SERVICE BULLETIN

Hydraulic Motor Changes

MODELS AFFECTED: 650939-X-B, 650940-X-B, 650941-X-C

RELEASED: 12-18-02
REVISED: 6-18-03
(REV. 03)
BULLETIN: #1-02

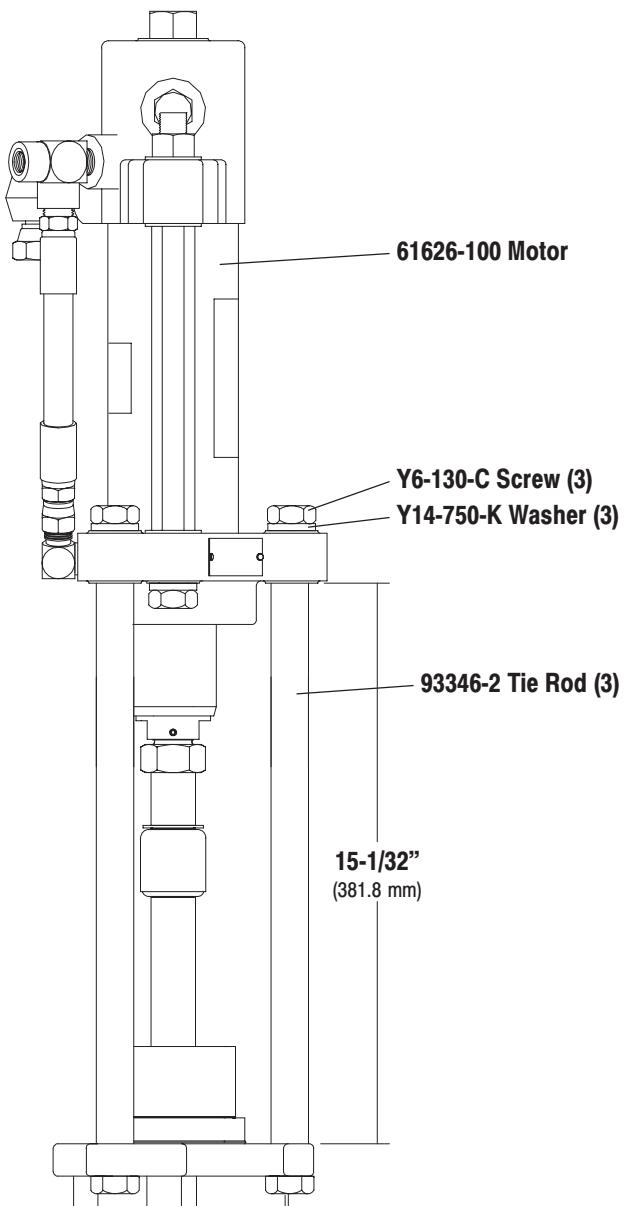
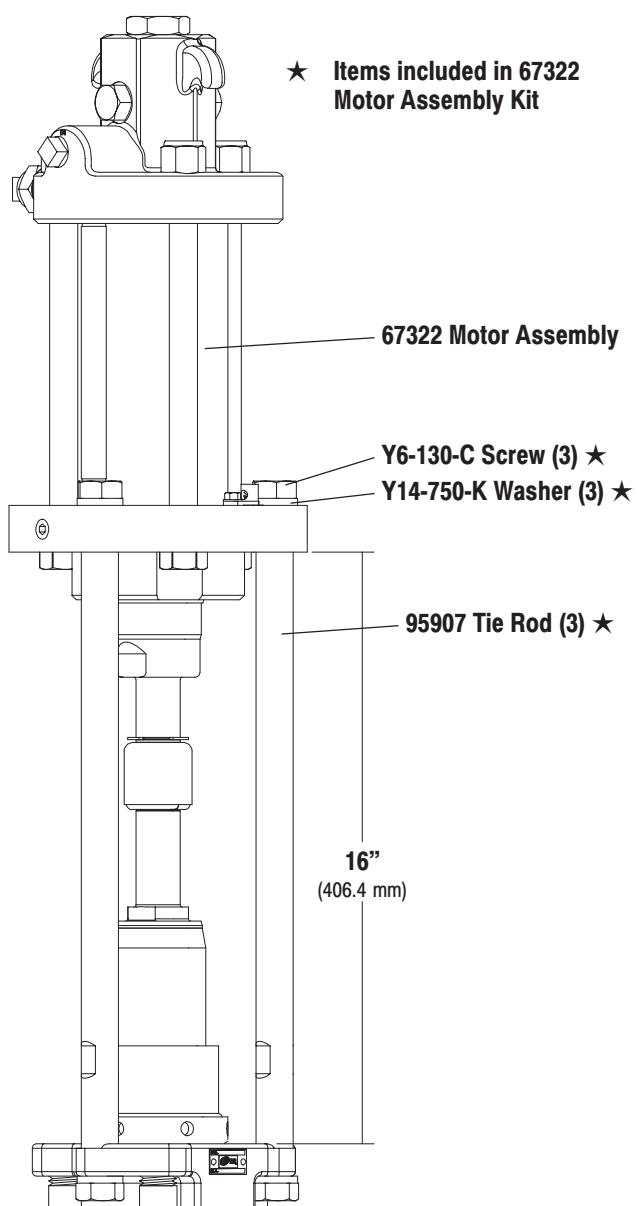
The following changes were made to 4.125 square" hydraulic motor.

- 1.) 61626-100 motor cancelled and replaced with 67322 motor assembly.
- 2.) Change effects models built after December 1, 2002 (S/N L0012-XXX).

Requires 61938-1 wall mount bracket.

Requires 62151 wall mount bracket.

For threaded pump connections, use 67325 Motor Assembly Kit.

OLD MOUNTING PLATE DESIGN (61938-1)

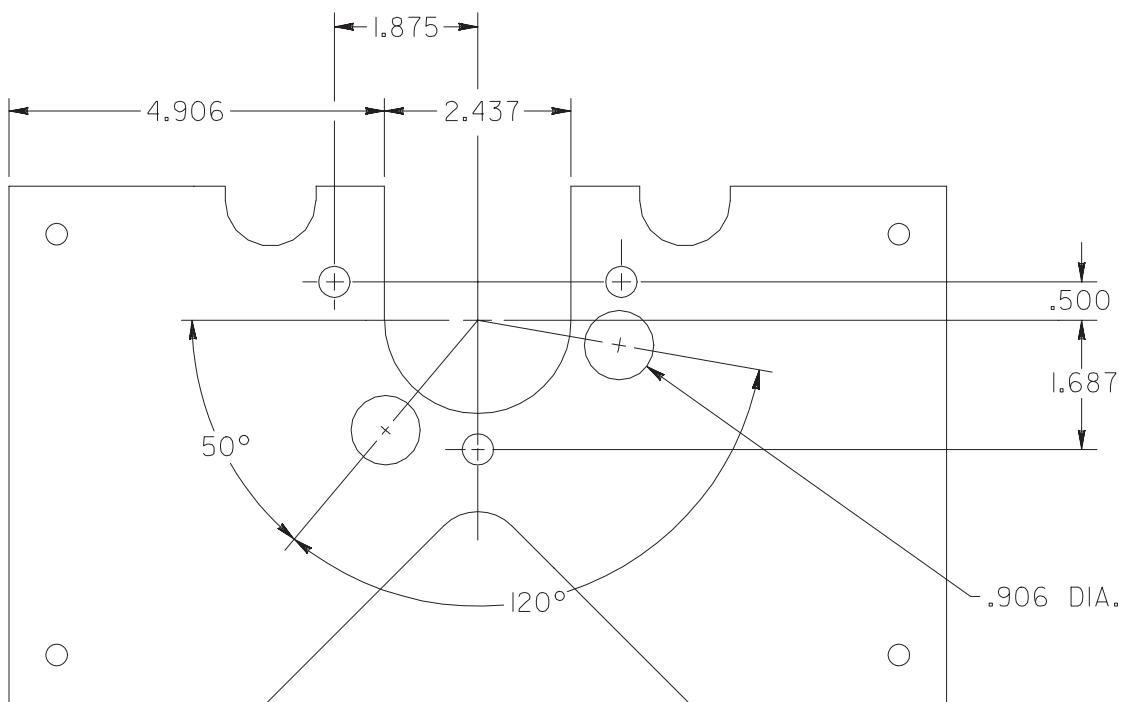
NEW MOUNTING PLATE DESIGN (62151)
